From: Naoise O'Connor [REDACTED]
Sent: Thursday, January 11, 2024 12:30 PM
To: Appeals2 <appeals@pleanala.ie>; Bord <bord@pleanala.ie>
Cc: SLA Dublin Central [REDACTED]
Subject: ABP Ref. 312603-22 - Response to Section 137 Request - Dublin Central Site 3

RE: RESPONSE TO SECTION 137 REQUEST

PLANNING APPLICATION FOR THE DEVELOPMENT OF MIXED-USE DEVELOPMENT IN 2NO. BLOCKS, RANGING IN HEIGHT FROM 1 TO 9 STOREYS OVER 2NO. INDEPENDENT SINGLE LEVEL BASEMENTS (GROSS FLOOR AREA C. 15,842.4 SQ M) AT NOS. 36 – 41 HENRY STREET, NOS. 1-9 MOORE STREET, NOS. 3-13 HENRY PLACE, DUBLIN 1 (DUBLIN CENTRAL – SITE 3)

AN BORD PLEANÁLA REF: ABP-312603-22

Dublin Central Site 3A

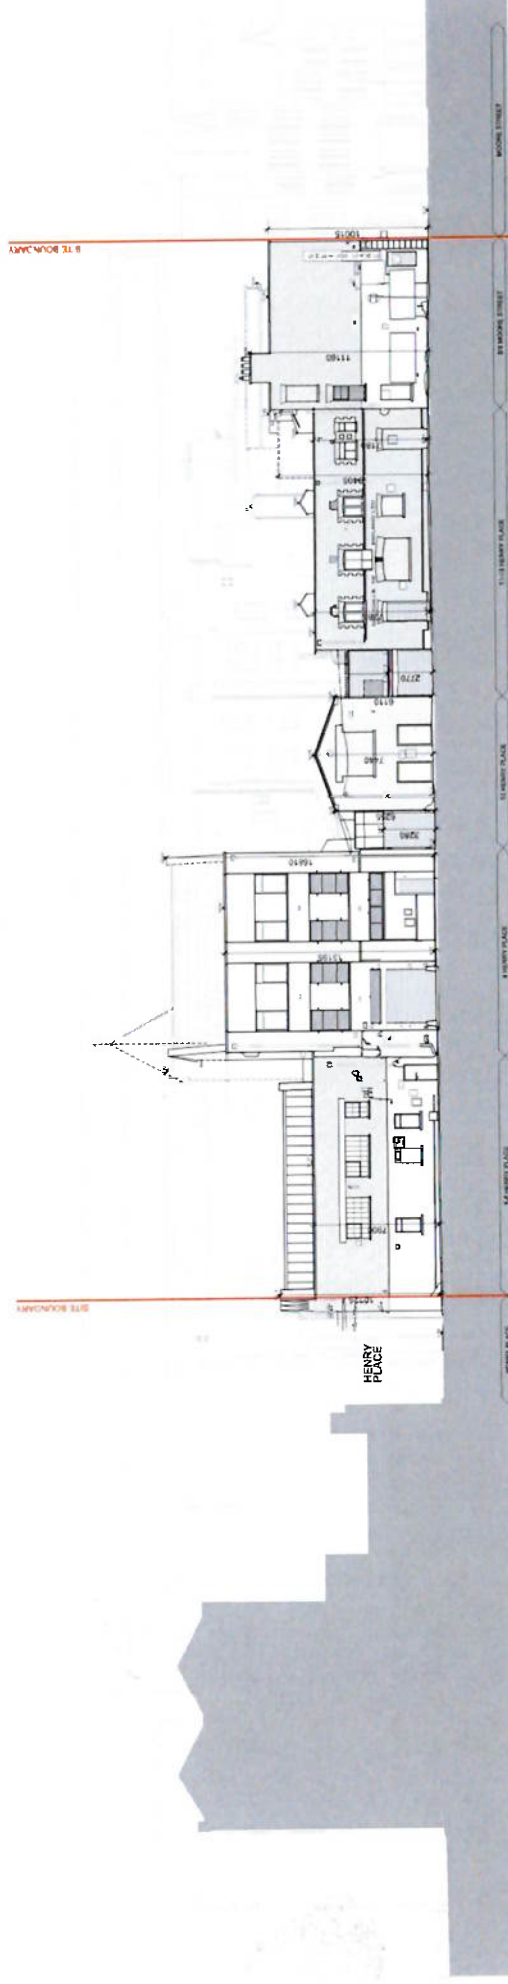
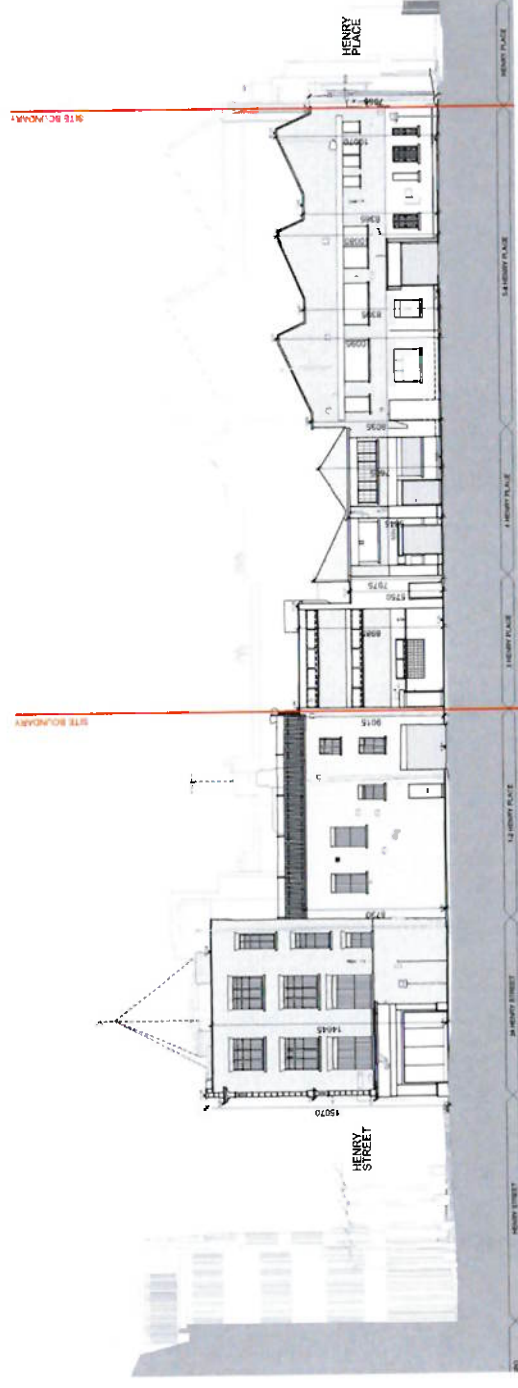
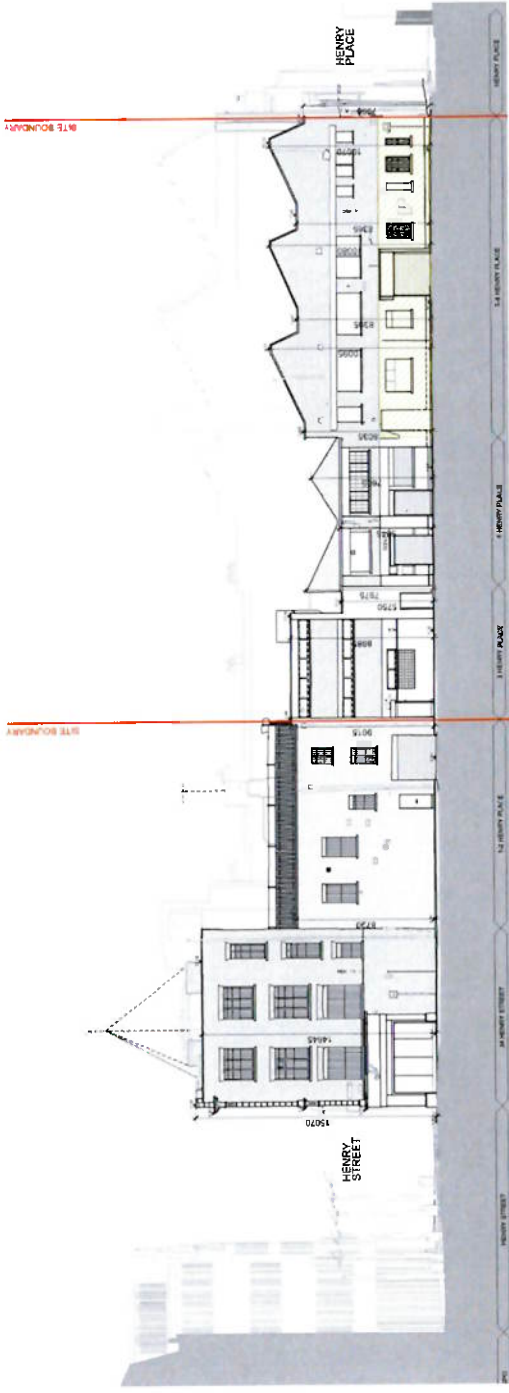
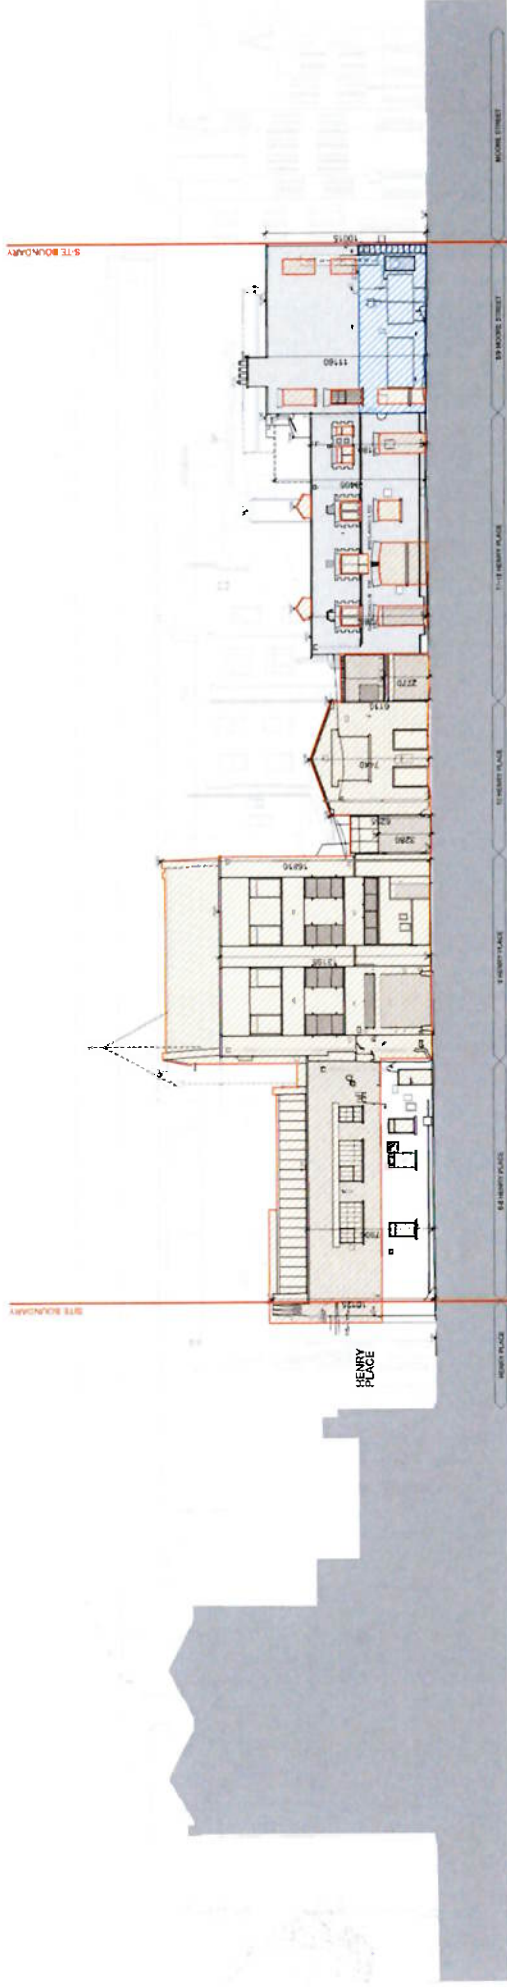
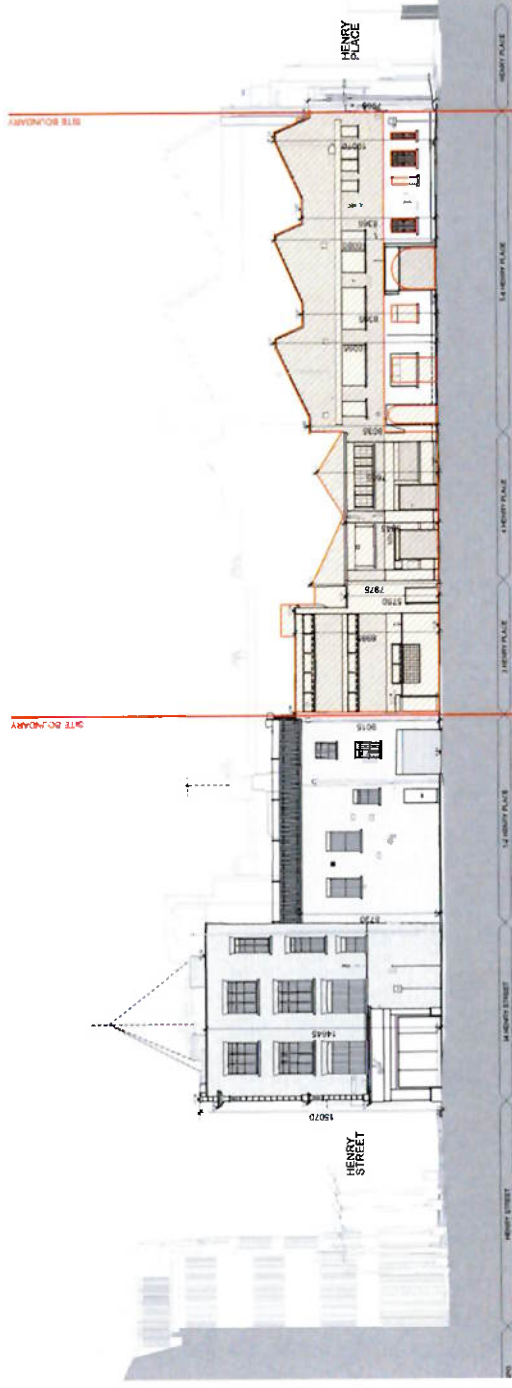
Taking account of the listing of built fabric at 4-8 Henry Place on the RPS, we take this opportunity to submit revised elevations to the Board (see MOLA Architects drawing nos. DC-MLA-3X-ZZ-M3-A-40-0401 and DC-MLA-3X-ZZ-M3-A-40-0402), which demonstrate a proposed design intent for the integration of the protected structure. Please note that these elevations do not yet reflect the implementation of Condition 6 of Dublin City Council's decision to grant permission in this case. In the proposed amendment design scenario, now before the Board for its consideration, the Protected Structure becomes an anchor for the project at the Henry Place corner, with the proposed contemporary hotel building rising vertically from it. Clerestory glazing and vertical breaks ensure that there is a distinct but sympathetic separation between the retained fabric and the contemporary architecture above. Minor amendments to the core arrangement and internal layouts will ensure that proposed door and window locations at ground floor work within the existing openings and will not disrupt or detract from its character but help re-establish the importance of the corner site by giving it a new purpose. We refer again to Section 2.6 of this report below for further discussion of this in the context of the built heritage policies of the current Development Plan.

Additions to the Record of Protected Structures Extent of Protected Structure (RPS Ref No: 8906)

Additions to the Record of Protected Structures Extent of Demolition at Henry Place
